## 5 COMMENTS AND RESPONSES TO COMMENTS

### 5.2.1 Letter A: Jeffrey R. Single, Regional Manager, Central Region, California Department of Fish and Game

**Subject: Draft Initial Study/Mitigated Negative Declaration  
PG&E Shepherd Substation Project, Fresno County, California  
SCH No. 2012051067**

EXHIBIT NO. 3  
**FRESNO METROPOLITAN FLOOD CONTROL DISTRICT**

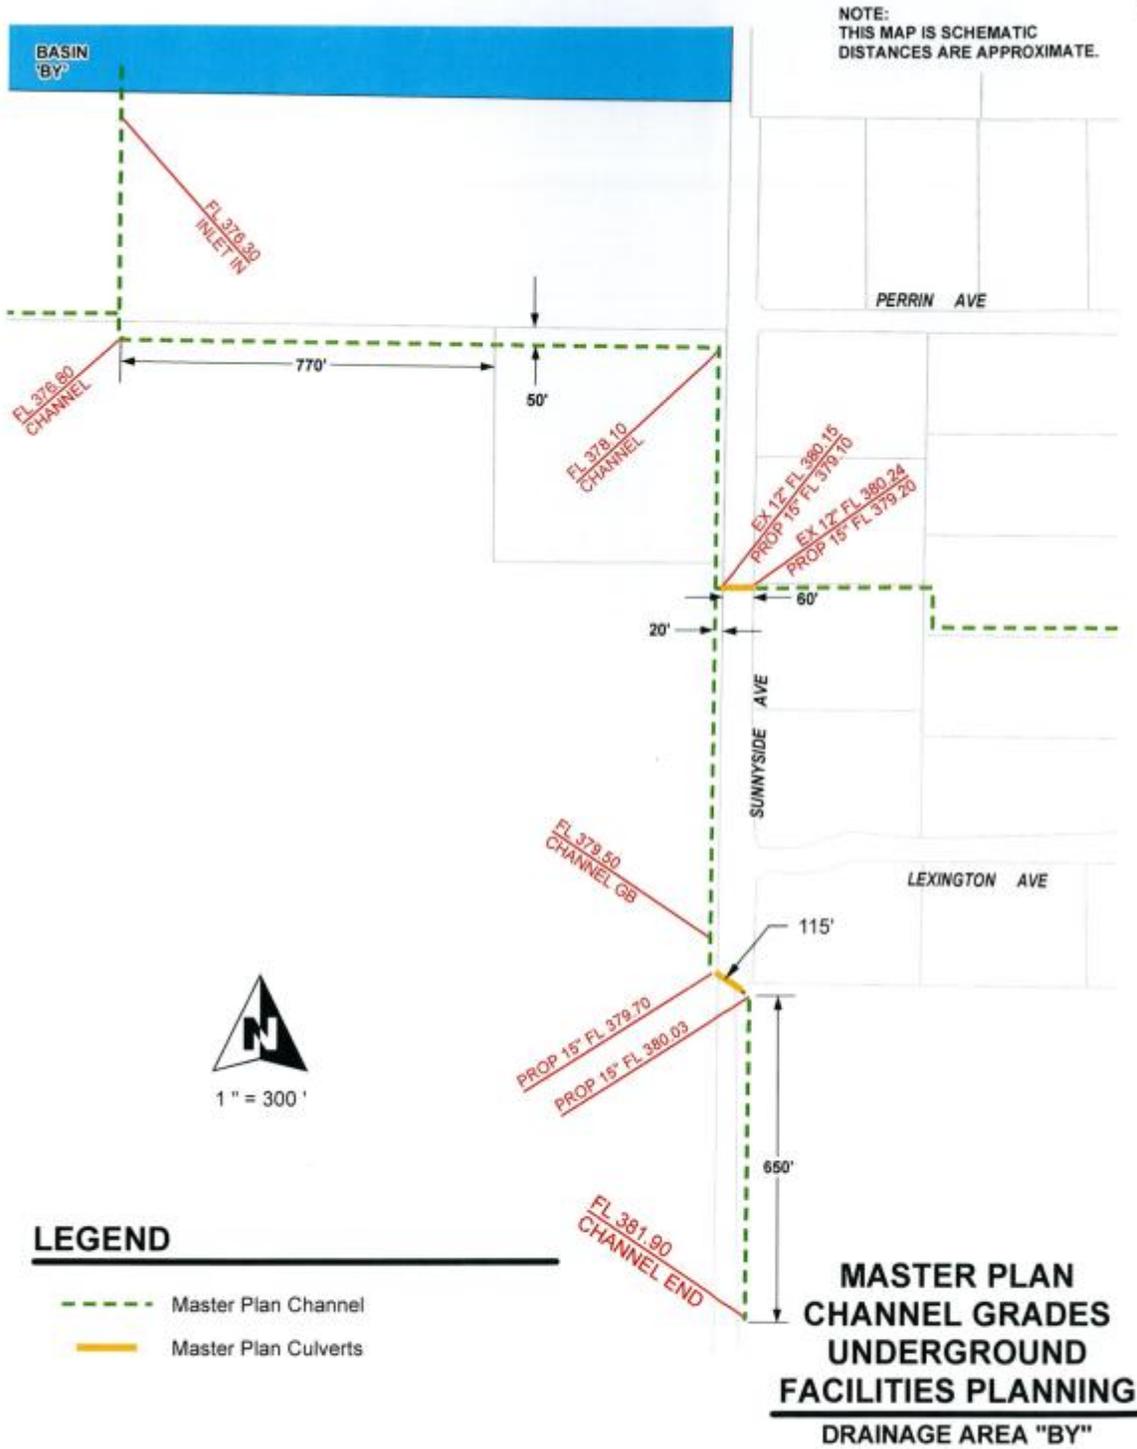
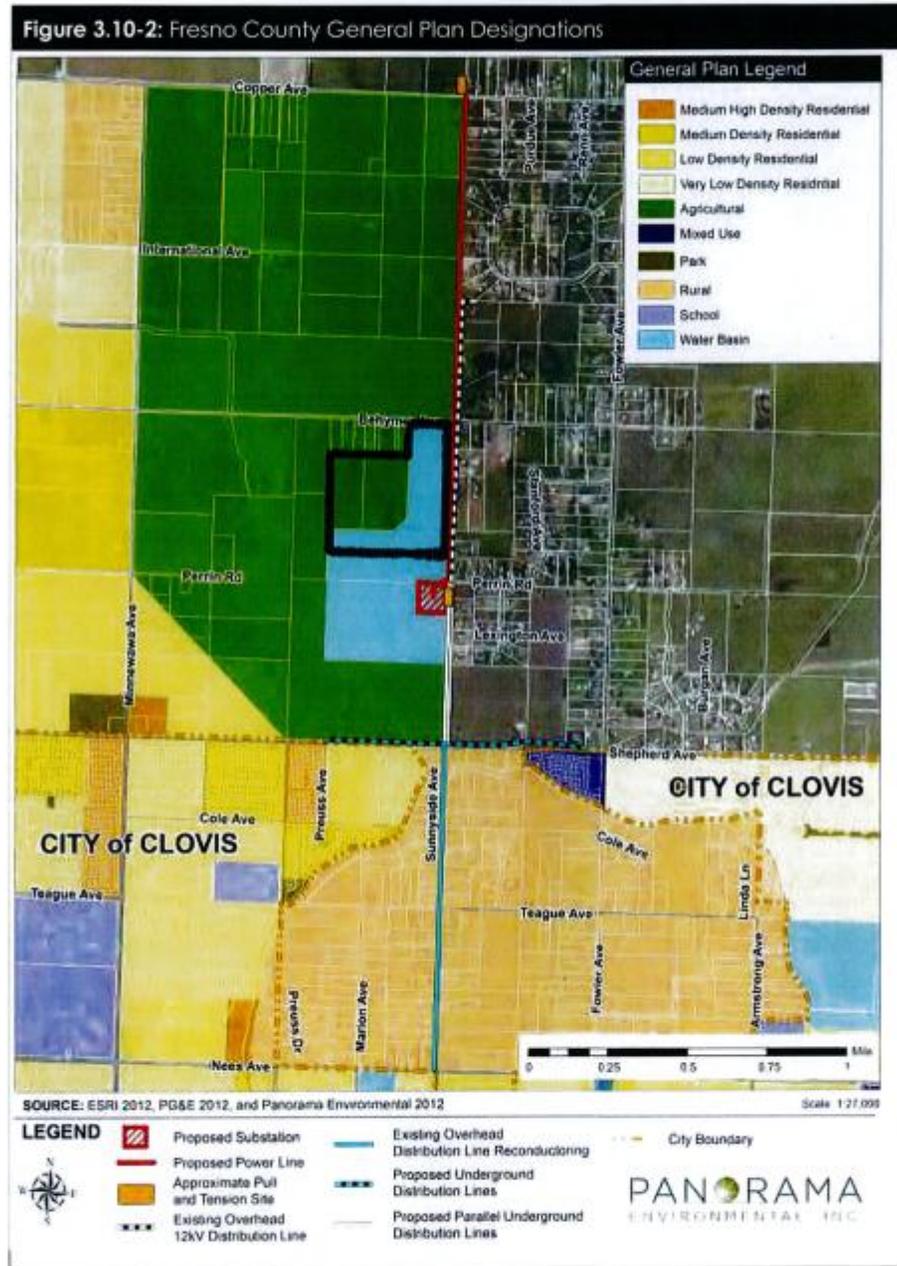
C-5 | At the substation site, the applicant should be aware that a Master Plan stream channel flows along the east and north boundaries of the property. Agricultural practices have severely encroached upon this historical stream course. The restoration, protection and preservation of this channel are necessary due to the proposed development activity. The preservation of this natural drainage pattern requires dedication of a permanent drainage easement to the District.

C-7 | Development of the substation shall be done in a manner such that sufficient area is provided for the restoration of this channel. The Master Plan flow rate for the channel is 24 cubic feet per second (cfs). It appears that the proposed development setbacks of 65 feet from Sunnyside and 75 feet from Perrin will provide adequate area for the channel; however, ultimate channel restoration will reduce the area available for the proposed landscape screening using the existing almond trees as described in the IS/MND.

**21-kV (2) and 12-kV underground distribution lines**  
 From the substation site, the Master Plan channel continues southerly along the west side of Sunnyside Avenue, crosses Sunnyside approximately 1,320 feet north of Shepherd Avenue and continues along the east side of Sunnyside another 650 feet. As a result, both the horizontal and vertical placement of the underground distribution lines must be coordinated with the District to ensure adequate cover on the underground distribution lines. The distribution lines should be located outside the Master Plan channel and the District can supply channel configuration and grades to assist in the design. The Master Plan has two channel culvert crossings in Sunnyside Avenue that the distribution lines will have to cross. One of the culverts is existing and to be replaced and one is proposed. These culverts must be placed at specific depths to accommodate the channel flow. The channel and culverts are shown on Exhibit No. 3.

PG&E is currently working with FMFCD to determine the feasibility of constructing a separate stormwater channel to the east and north of the substation as shown in the FMFCD Master Plan (Exhibit No. 3 in the FMFCD letter). The potential stormwater channel is added to the Project Description. The underline text below and on Pages 2-18 and 2-19 reflect this change:

- C-7 PG&E plans to maintain setbacks of 75 feet from Perrin Avenue and 65 feet from Sunnyside Avenue. PG&E is reviewing the feasibility of constructing a stormwater channel to the north and east of the substation that would accommodate the FMFCD Master Plan flow rate of 24 cfs. APM Visual-1 is being revised to provide visual screening of the substation while allowing greater flexibility in siting a stormwater channel as shown on the Master Plan. The text of APM Visual-1 has been revised as follows:
